Addendum #1

Tender #26051 – New Dain City (South Welland) Elementary School

Issue date: May 6, 2026

ADDENDA

SHEET TITLE: TYPICAL DETAILS

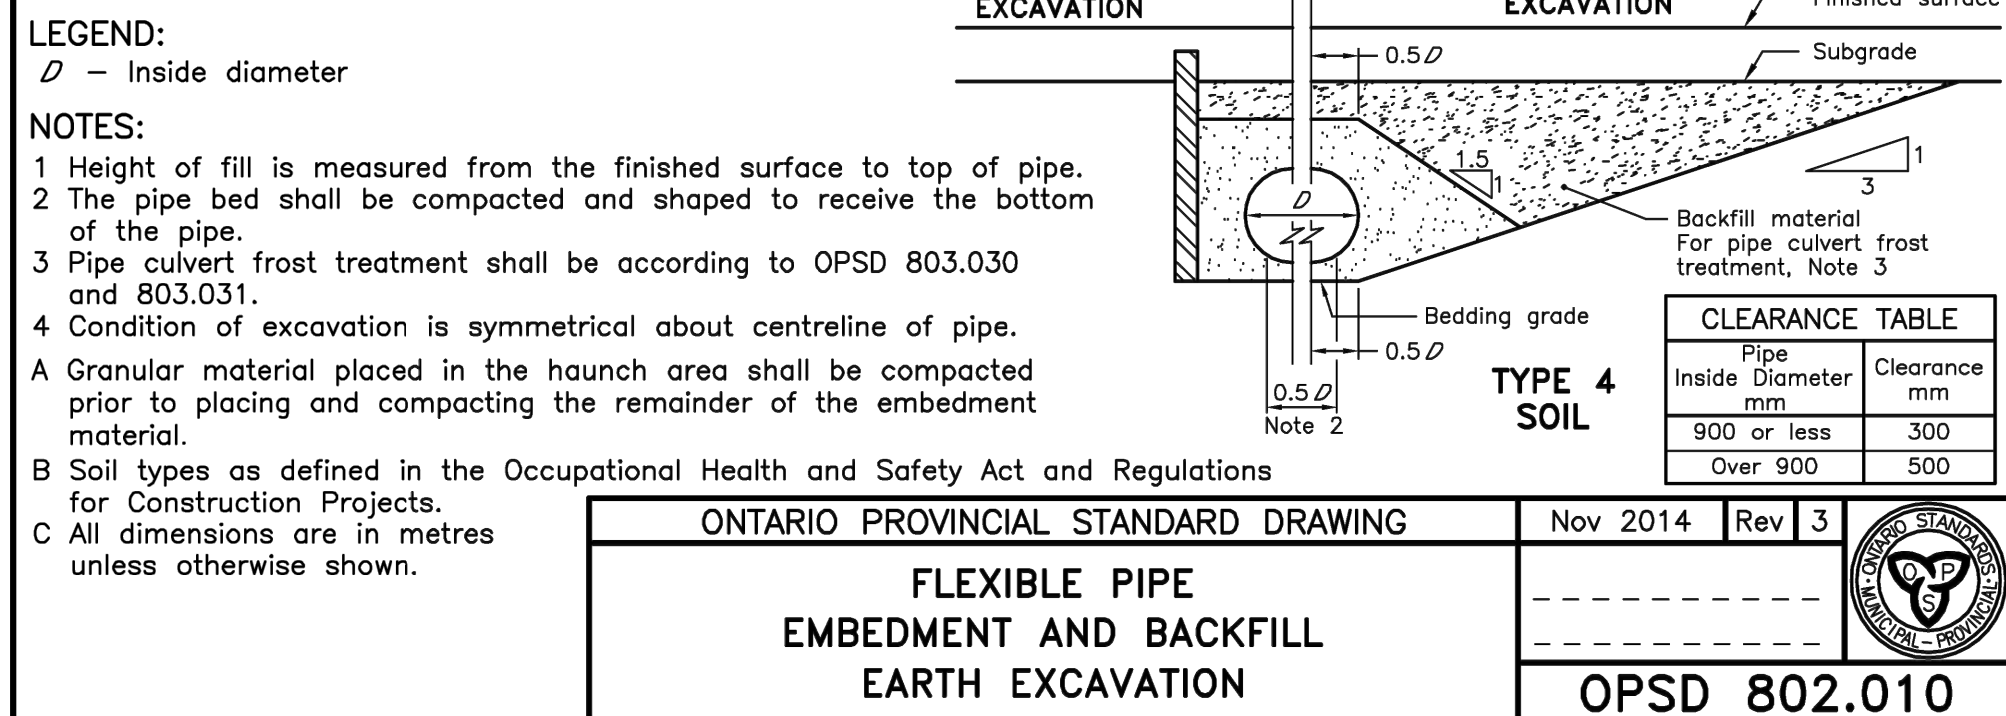
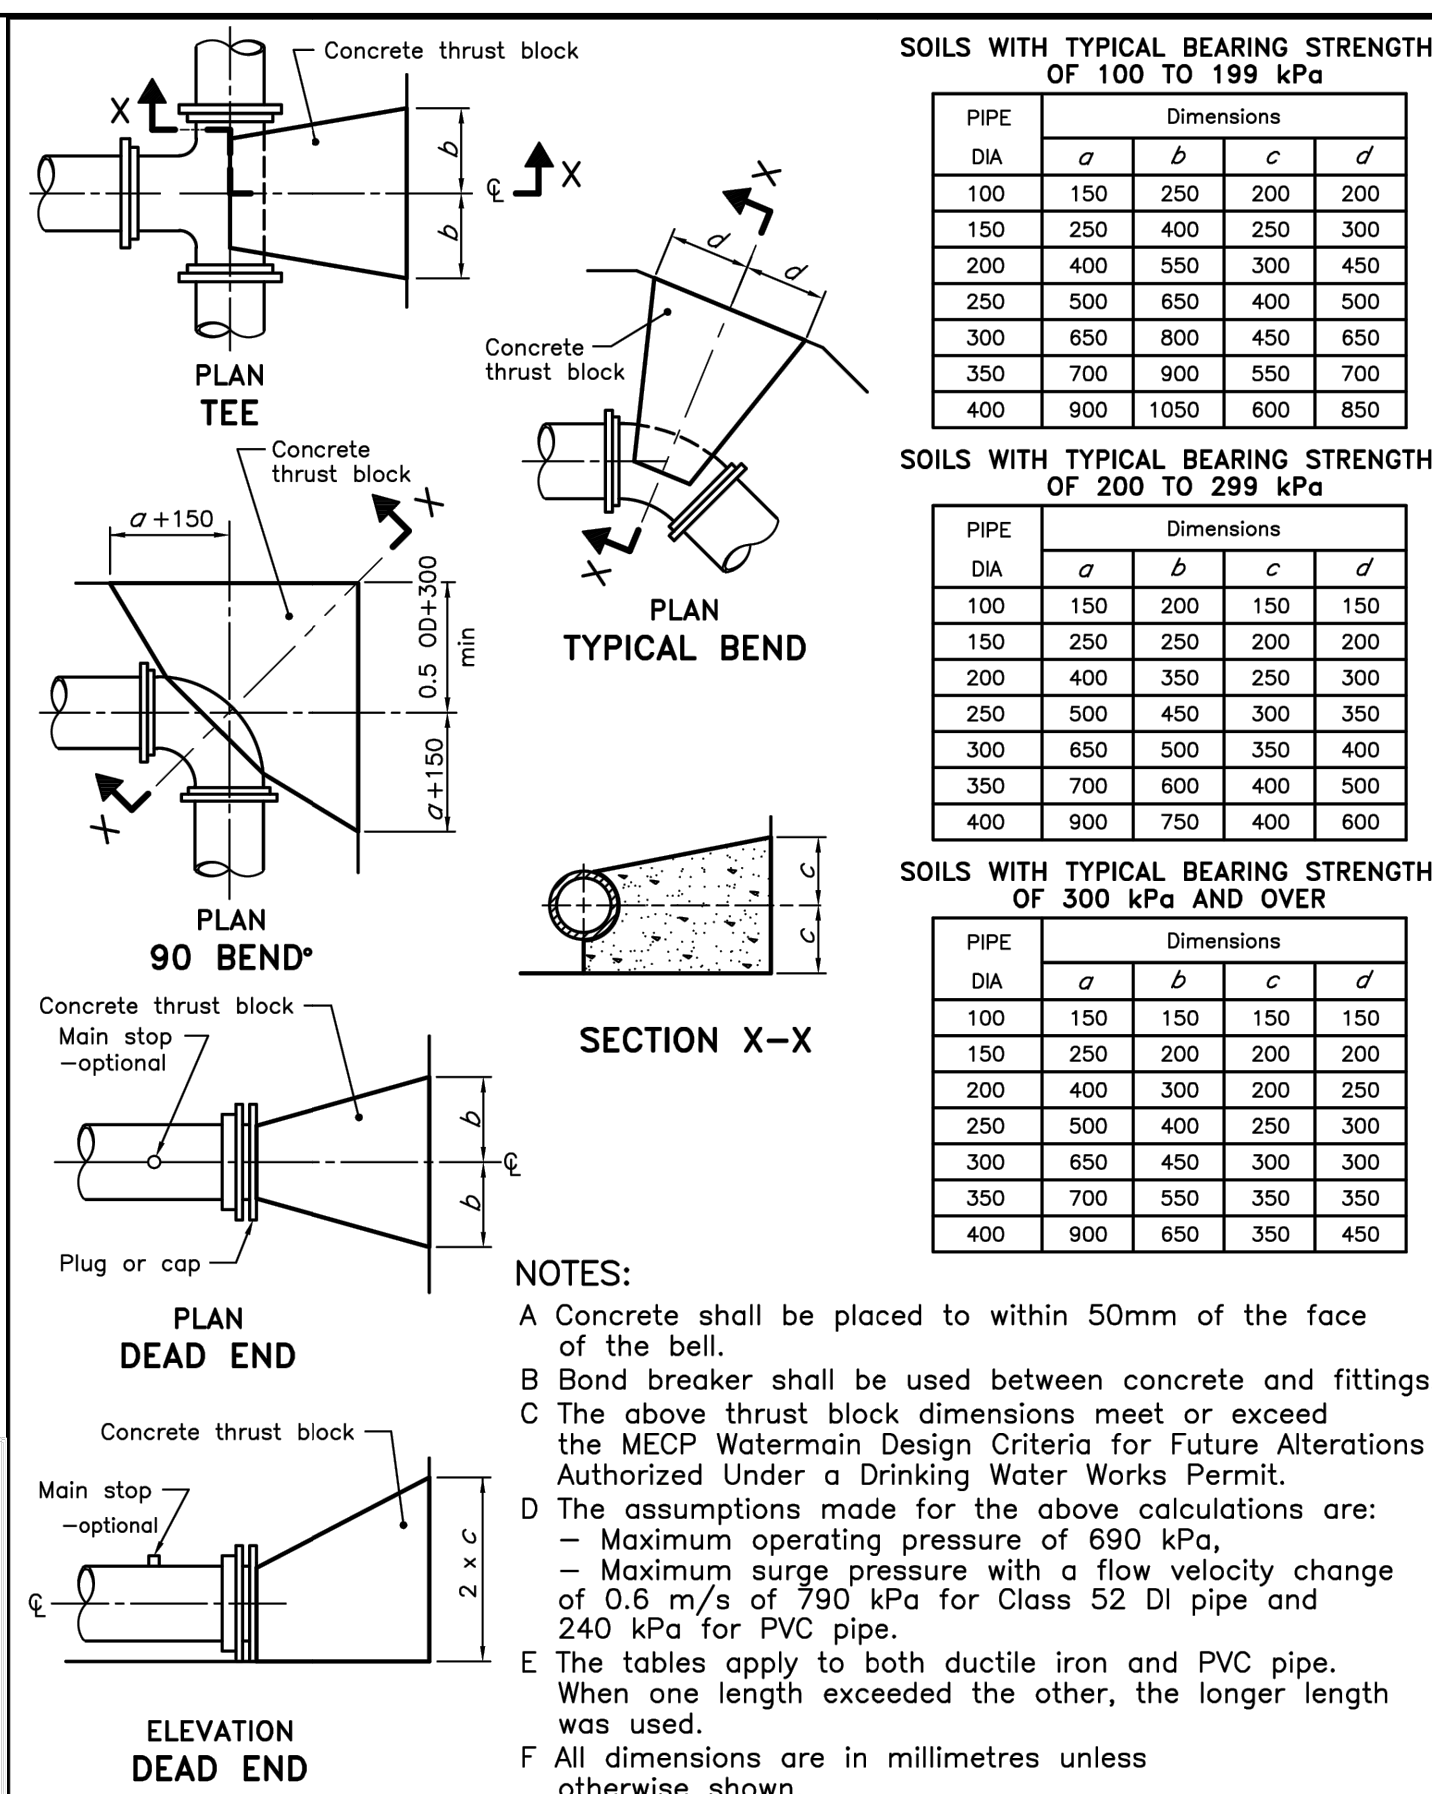
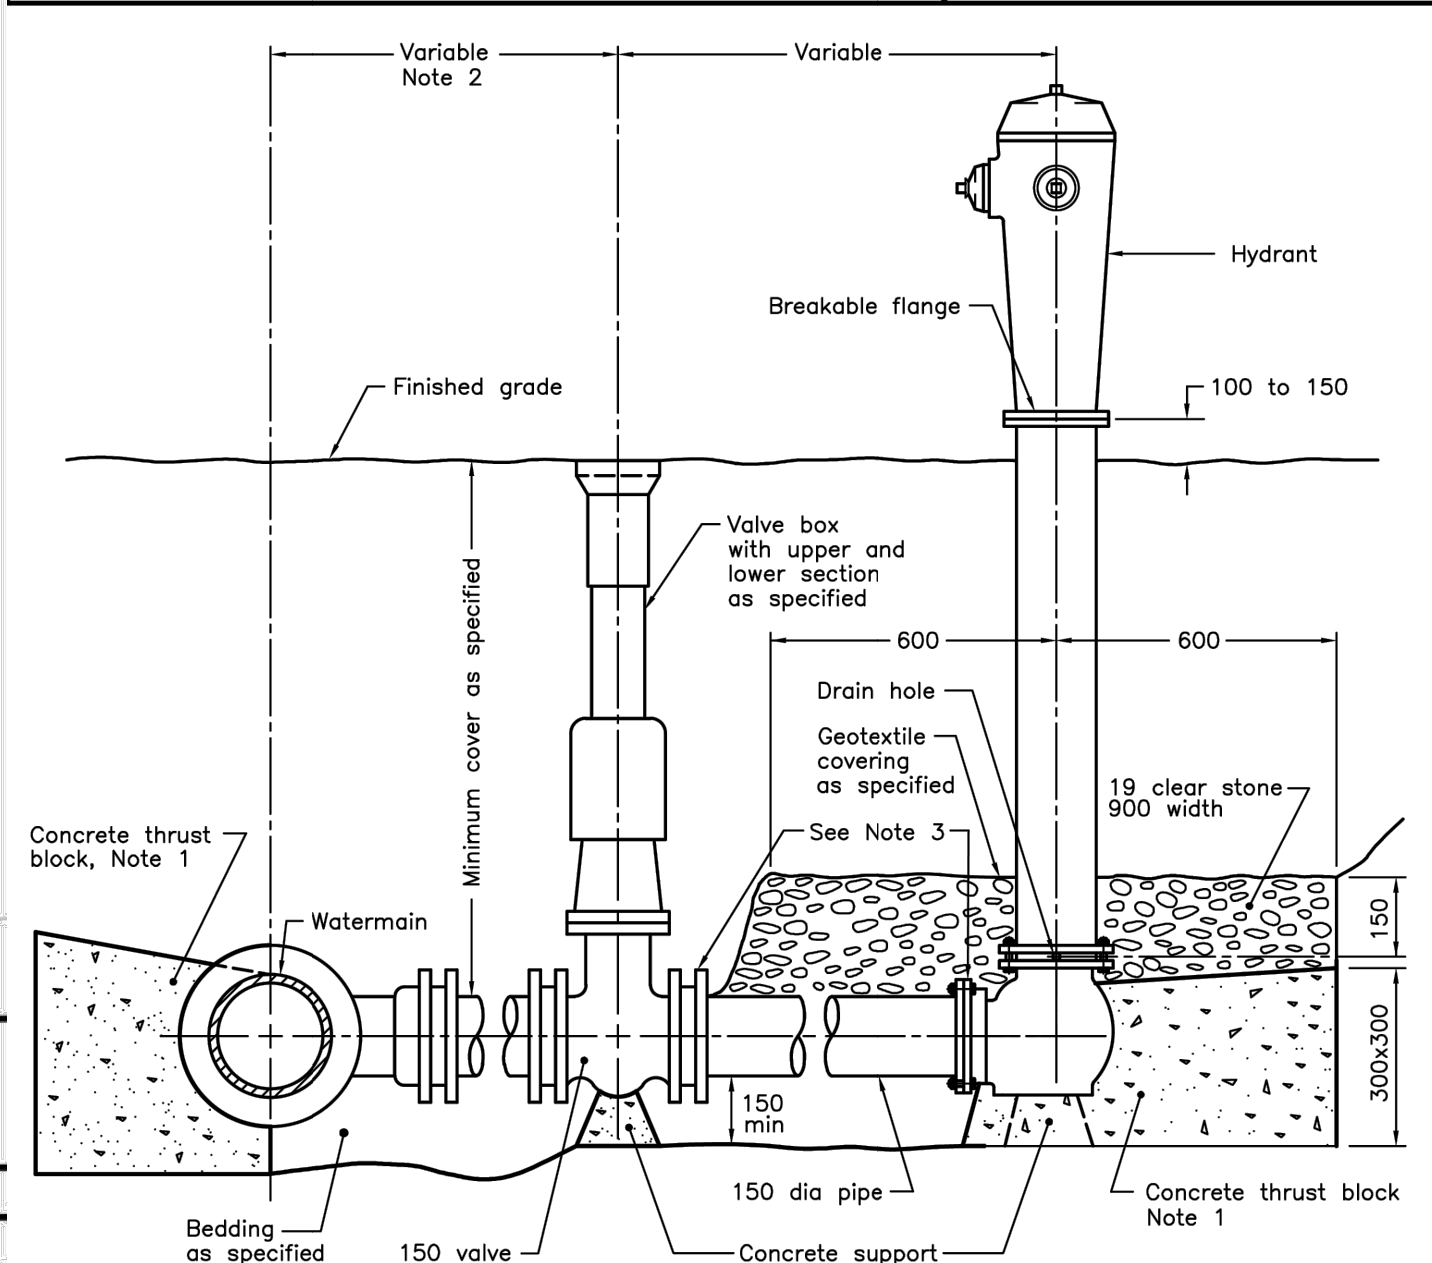
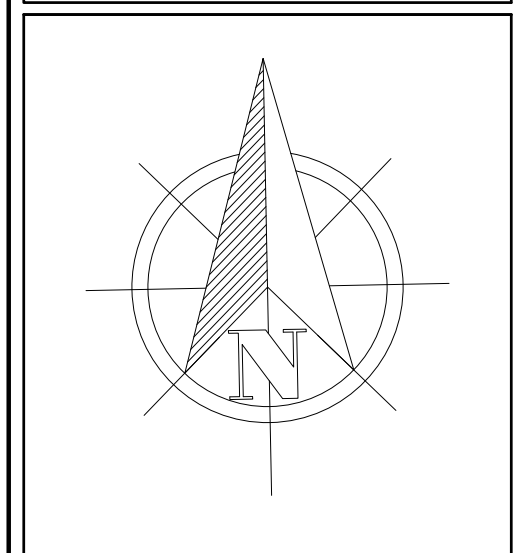
13. See attached revised civil drawings and Water Drop Structural Detail.
 - a. Refer to drawing C0.2.
 - i. Delete Piping Layout for Water Meters in Building with By-Pass OPSD 1107.030 detail.
 - ii. Clarification - see attached Watermain Drop Structural detail.
 - b. Refer to drawing C1.
 - i. Revise Fire Department Connection 'FDC' location as shown.

SHEET TITLE:
EXTERIOR SLAB DETAIL

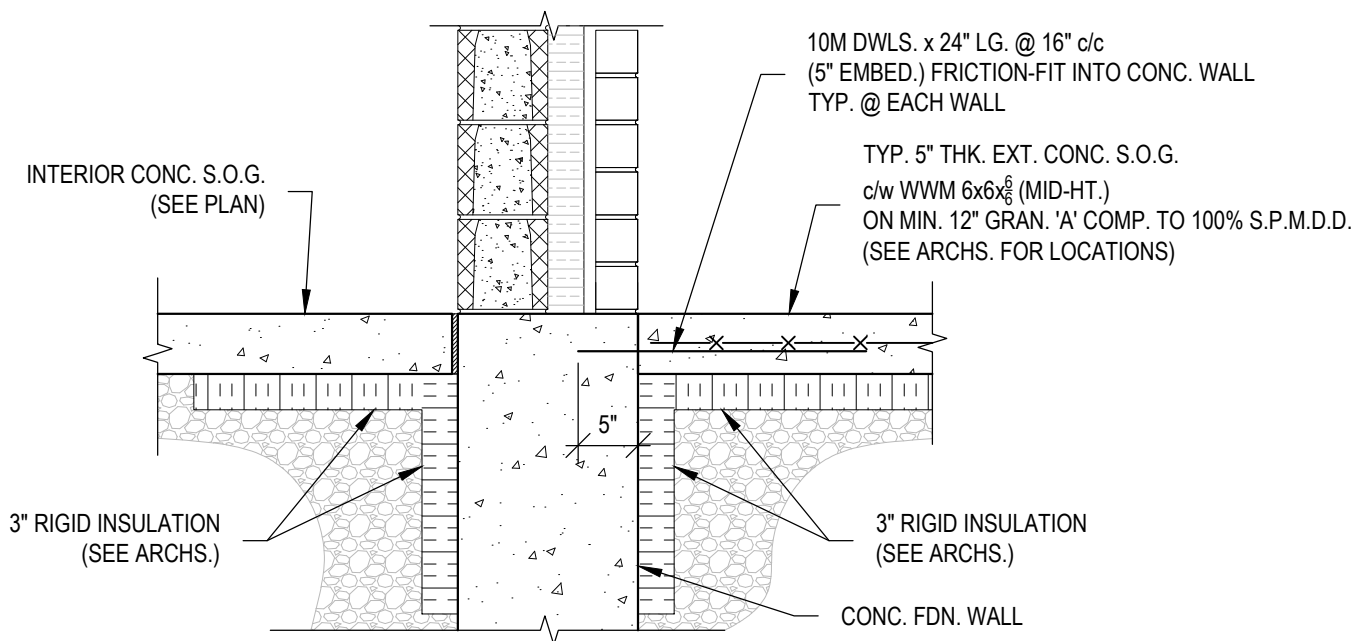
14. See attached SSK2 frost slab detail.

**PARTIAL GROUND
 FLOOR PLAN
 WASHROOM 100-9
 LIGHTING LAYOUT**

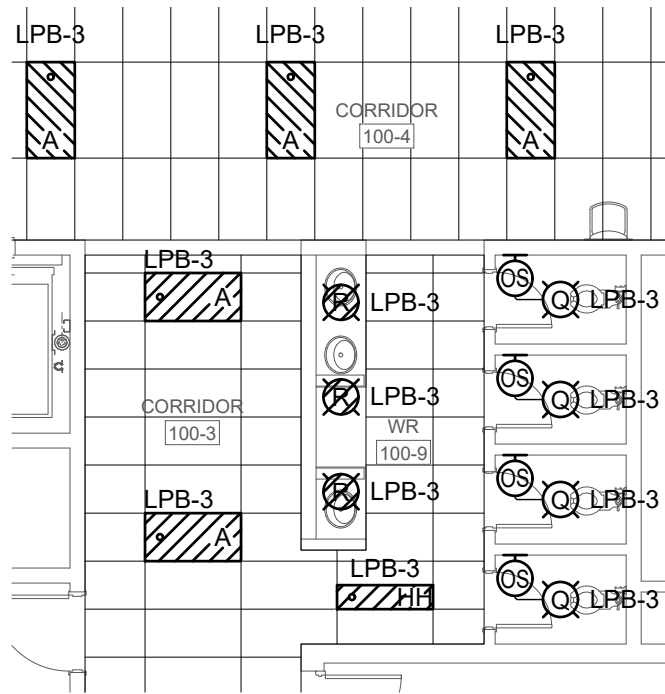
- a. WR 100-9: Revise the number of light fixtures tagged Q located above the lavatories from 5 to 3.
9. Refer to drawing A6-4 Third Floor Reflected Ceiling Plan,

Item	Description	Reference
1	Refer to Drawing E2-1, E2-2, E2-3, E2-4, A6-1, A6-2, A6-3, A6-4; supply and install new recessed pot lights fixture type "R" in corridors. Wire and control with light fixtures in corridors.	Drawing E2-1, E2-2, E2-3, E2-4, A6-1, A6-2, A6-3, A6-4
2	Refer to drawing E2-3 Second Floor Plan New Lighting Layout Learning Commons Stairs 212A; delete fixture type "D" and replace with fixture type "A."	Drawing E2-3
3	Refer to attached sketch SKE-1. Provide emergency remote light fixture in daycare wing as shown.	Sketch SKE-1
4	Refer to drawing E5-2 Power Risers and Panel Schedules drawing note 1; revise note catalogue number to TK-ST200-3Y208-LB.	Drawing E5-2
5	Refer to drawing E5-2 Power Risers and Panel Schedules New Power Riser; revise switchboard to 800Amp 120/208V - 3 Phase - 4 Wire Switchboard.	Drawing E5-2
6	Refer to attached sketch SKE-2; Supply and install type "R" light fixtures in WR 100-9 as shown. Remove type "H" light fixture in WR 100-9 as shown.	Sketch SKE-2

STAIR LIGHTING
LAYOUTS

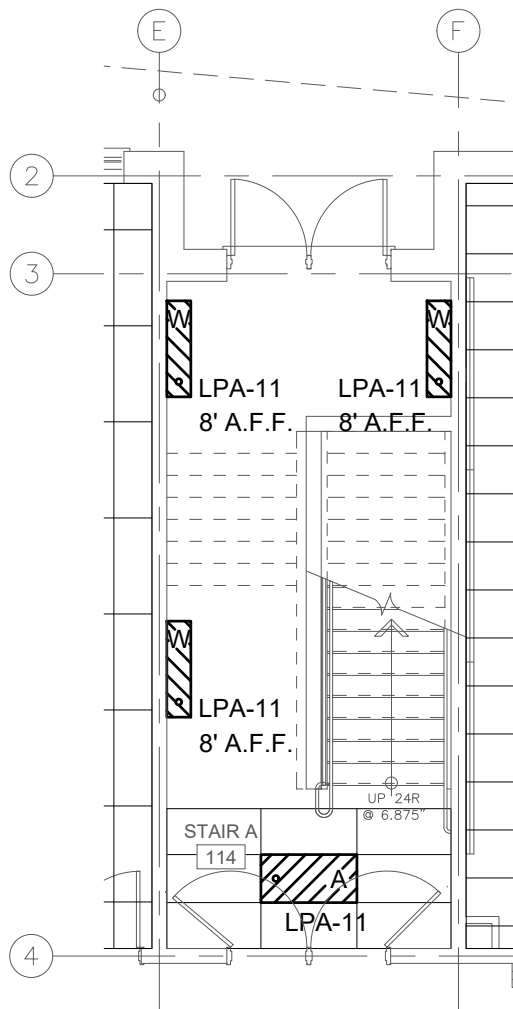
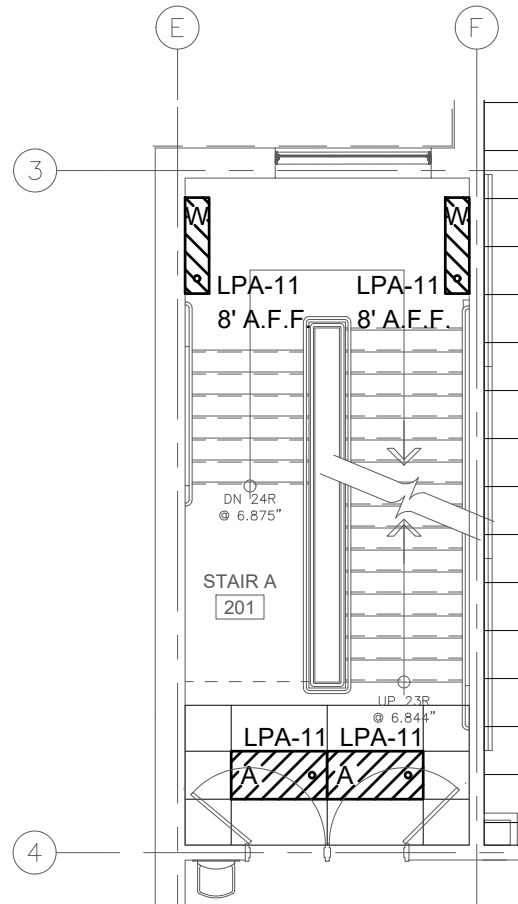
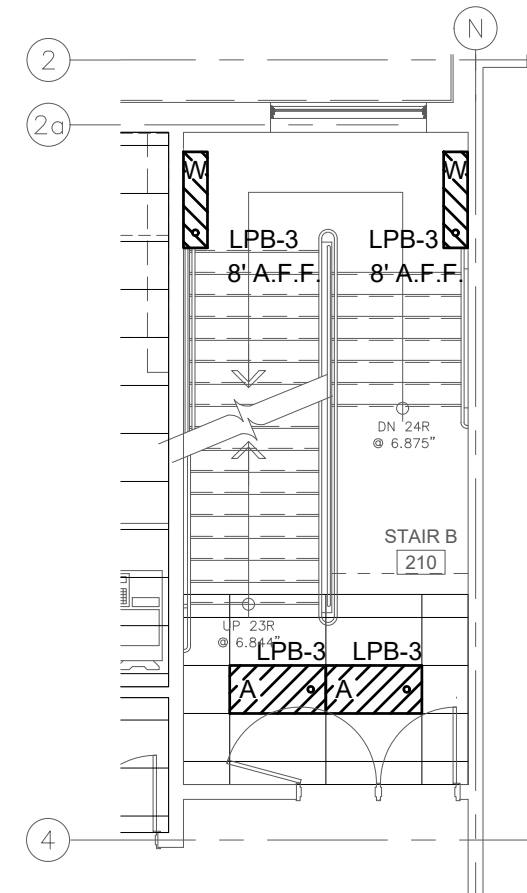
10. Refer to drawing A6-1 Partial First Floor Reflected Ceiling Plan,
 - a. Stair A 114: Revise the light fixtures tagged H to 3 wall mounted light fixtures.

11. Refer to drawing A6-3 Second Floor Reflected Ceiling Plan,
 - a. Stair A 201: Revise the light fixtures tagged H to 2 wall mounted light fixtures.
 - b. Stair B 210: Revise the light fixtures tagged H to 2 wall mounted light fixtures.

7	Refer to attached sketch SKE-3; Replace type "H" fixtures in stairwell with type "W" wall mounted light fixtures as shown. Refer to drawing E2-4 Light Fixture Schedule; Add type "W" to light fixture schedule CAT#4SWLED-40SL-LC-UNV-L840-CD1.	Sketch SKE-3, Drawing E2-4
8	Refer to drawing A2-1 Kindergarten Outdoor Storage 132; Add 1x type "E" light fixture and wall mounted occupancy sensor to room. Wire to circuit LPA-2.	Drawing A2-1
